ADDENDUM NO 4
2023-04
Ellisville to Ft. White Water Main Extension

Columbia County - Ellisville To Ft White Water Main Extension

Columbia Co Bid No. 2023-04

ADDENDUM NO 4

SHEET NO.
91

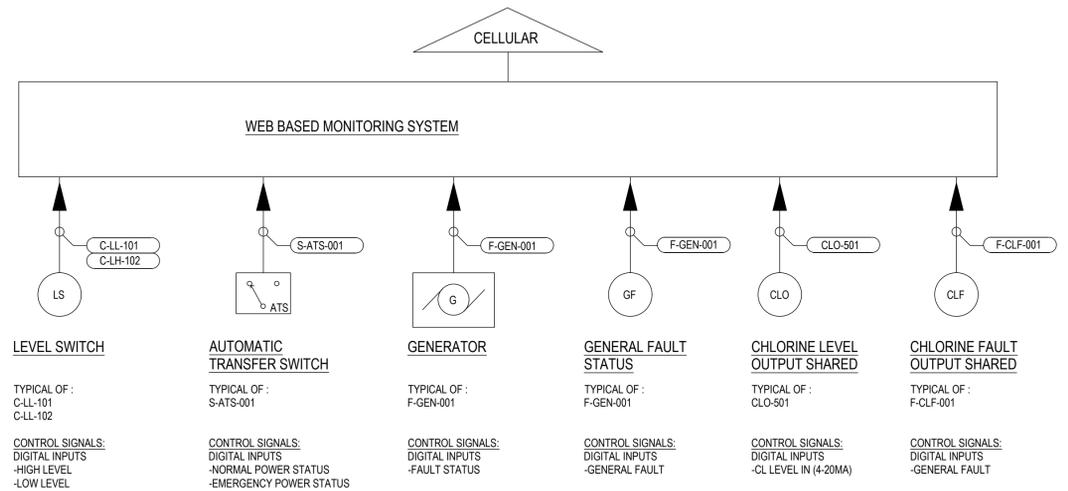
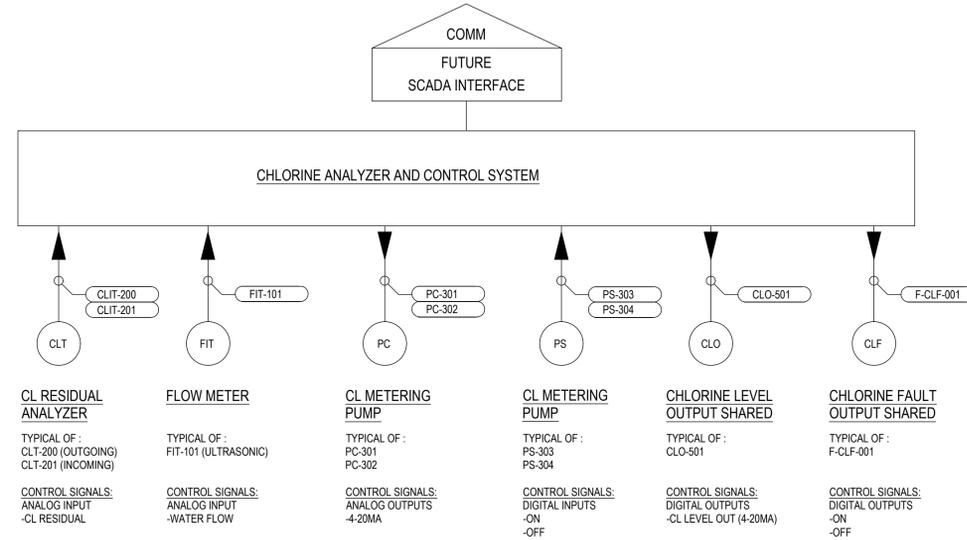
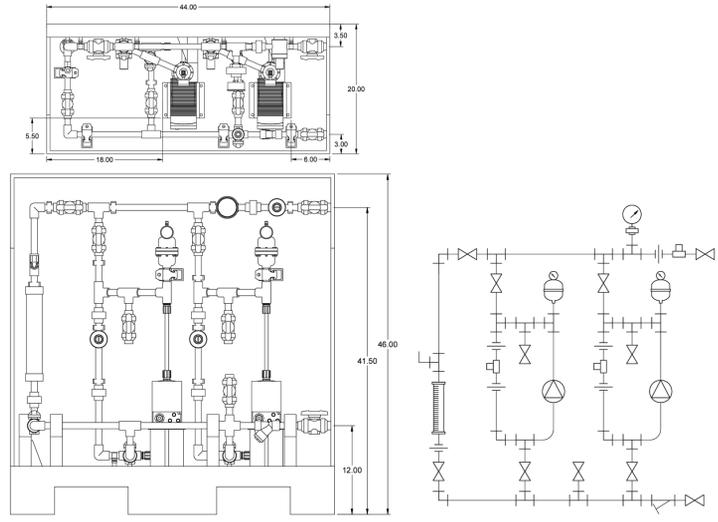
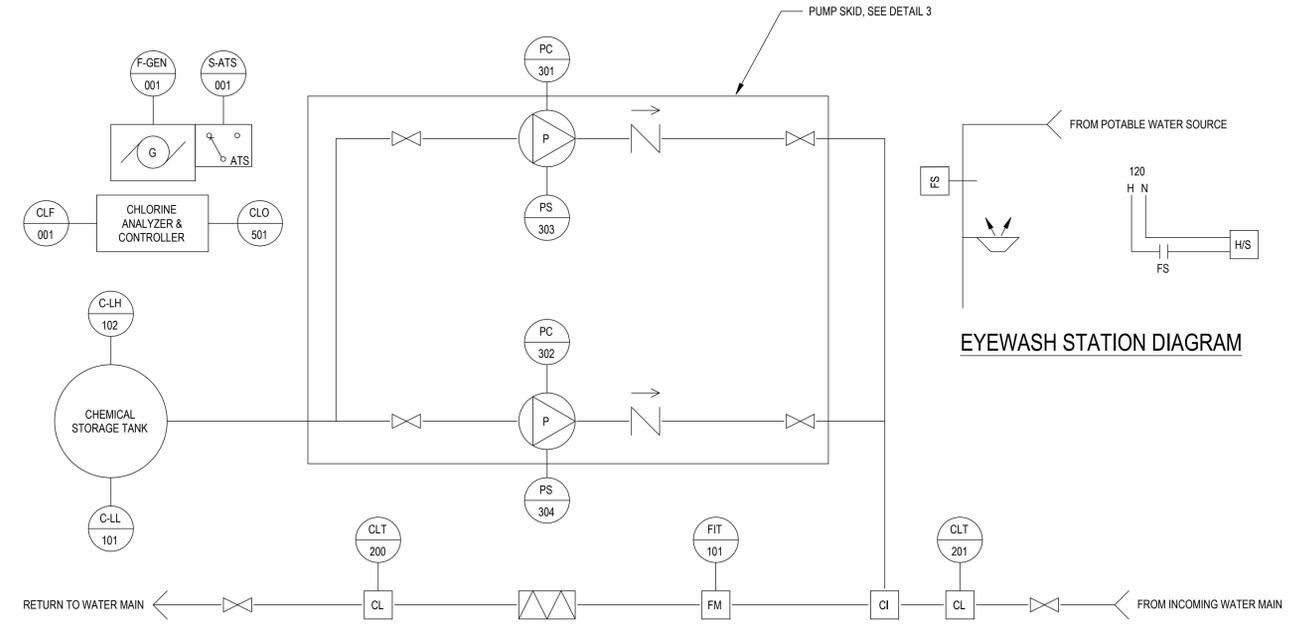
1. In Project Drawings, replace Sheet 2 with the attached Sheet 2. Note the updated EOR signature block.
2. In Project Drawings, replace Sheet 91 with the attached Sheet 91. Note the addition of an Electric Fan schedule and a Unit Heater schedule.

- A4. An exhaust fan schedule and a unit heater schedule have been added to the attached replacement Drawing Sheet 91.**
- Q5. Is a construction cost estimate available?*

EXHAUST FAN SCHEDULE		UNIT HEATER	
MARK	EF-1	MARK	UH-1
MANUFACTURER	GREENHECK	MANUFACTURER	BRASCH
MODEL	AER-20-VG	MODEL	240 SERIES
TYPE	SIDEWALL DIRECT	TYPE	ELECTRIC WALL MOUNT
DRIVE	STARTER	DRIVE	STARTER
AIRFLOW (CFM)	250	AIRFLOW (CFM)	650
TSP (IN WG)	0.28	KW RATING	6.7
COATING TYPE	INDUSTRIAL GREY EPOXY	COATING COLOR	CAMEL
MOTOR SECTION		MOTOR SECTION	
VOLTS-PHASE	115/1	VOLTS-PHASE	240/1
BHP/HP	1/4	BHP/HP	1/4
DRIVE TYPE	DIRECT	DRIVE TYPE	DIRECT
MOTOR SPEED (RPM)	1350	MOTOR SPEED (RPM)	1750
SCHEDULE NOTES	(1)(2)(3)	SCHEDULE NOTES	(1)(2)(3)(4)(5)
SCHEDULE NOTES (1) PROVIDE BACKDRAFT DAMPER, GRAVITY-OPERATED (2) PROVIDE THERMAL OVERLOAD (3) PROVIDE WALL HOUSING, INLET GUARD, AND GALVANIZED 45-DEG WEATHERHOOD WITH INSECT SCREEN		SCHEDULE NOTES (1) 2-STAGE CONTROL (2) BUILT IN THERMOSTAT (3) 24VAC TRANSFORMER AND DISCONNECTING MAGNETIC CONTACTOR (4) CABINET - HEAVY GAUGE STEEL WITH BAKED ON POLYESTER POWDER COAT (5) DIRECTIONAL LOUVERS
